Circular Informativa

N.º 113/CD/550.20.001

Assunto: **GeneFinder COVID-19 Plus RealAmp Kit**

TECHNICAL NOTE

Non-specific amplification signal trace on Applied Biosystem 7500 Fast Dx

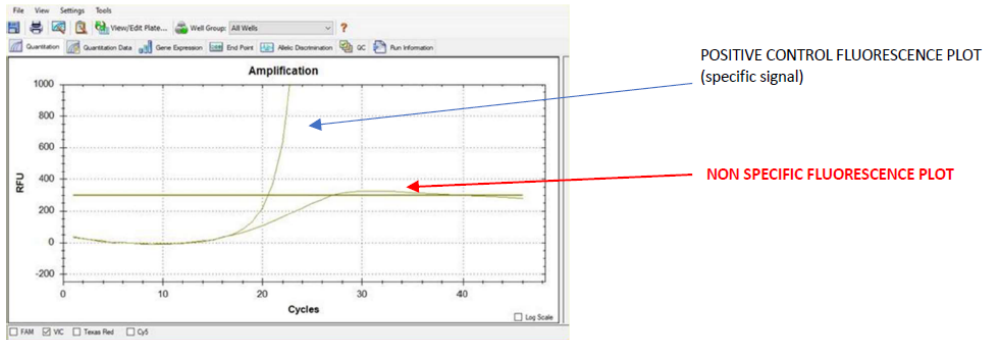
Below are some examples of non-specific fluorescence signals due to "high background found" on different equipment.

This background signal, higher than normal, if exceeds the detection threshold and if the amplification graphs are NOT checked, may be interpreted as a positive result.

For the analysis of the tests performed by the products belonging to the production batches shown on the first page of this document, it is recommended to change the threshold values as shown below.

Target	Before				Target	After			
	Threshold		Baseline			Threshold		Baseline	
	ABI	CFX96	Start	End		ABI	CFX96	Start	End
RdRp gene	30,000	300	3	15	RdRp gene	30,000	300	3	15
N gene	30,000	300	3	15	N gene	100,000	1,000	3	15
E gene	30,000	300	3	15	E gene	30,000	300	3	15
IC	10,000	100	3	15	IC	10,000	100	3	15
